**Work Order ID 112869**

Item Name: Fwd Crosstube

DRAWING NO. D407-667-145	TITLE CROSSTUBE ASS'Y (407 HIGH FWD)	REV. C	<b>DART AEROSPACE LTD ENGINEERING ORDER</b>		D.E.O. NO. D407-667-145-C-1	SHEET NO. SHEET 1 OF 1	SCALE NTS
DRAWN <i>qp</i>	CHECKED <i>ASS</i>	MFG. APPR. <i>is</i>	APPROVED <i>WD</i>		DE APPR. <i>##</i>		
DATE 11.07.15	DATE 11.07.22	DATE 11.07.22	DATE 11/07/22		DATE 11.07.21

DRAWING NO. D407-667-145	TITLE CROSSTUBE ASS'Y (407 HIGH FWD)	REV. C	DART AEROSPACE LTD ENGINEERING ORDER		D.E.O. NO. D407-667-145-C-2	SHEET NO. SHEET 1 OF 1	SCALE NTS
DRAWN AJS	CHECKED	MFG. APPR.	APPROVED	DE APPR.			
DATE 12.08.02	DATE 12.08.02	DATE 12.08.02	DATE 12.08.02	DATE 12.08.02

**DETAIL P**  
BONDING STRAP INSTALLATION 2 PL

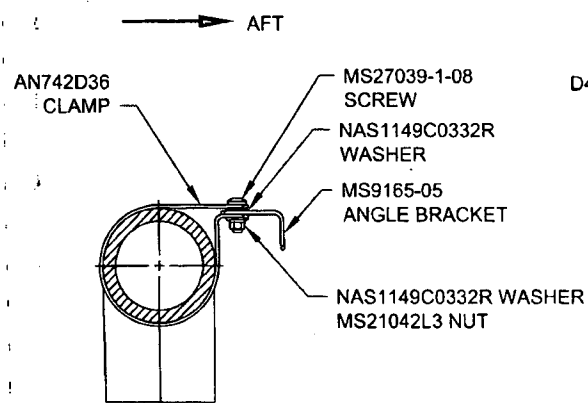
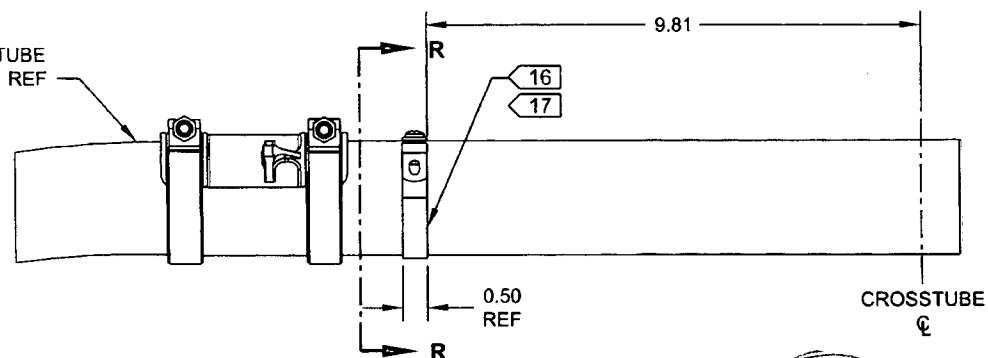
ADD ELECTRICAL GROUNDING STRAP

ITEM	QTY -145	PART NUMBER	DESCRIPTION
1	X	D407-667-145	CROSSTUBE ASSEMBLY (407 HIGH FWD)
10	2	AN742D36	CLAMP
11	2	MS9165-05	ANGLE BRACKET
12	2	MS21042L3	NUT (OR MS21042-3)
13	2	MS27039-1-08	SCREW
14	4	NAS1149C0332R	WASHER (OR AN960C10L)

ADD
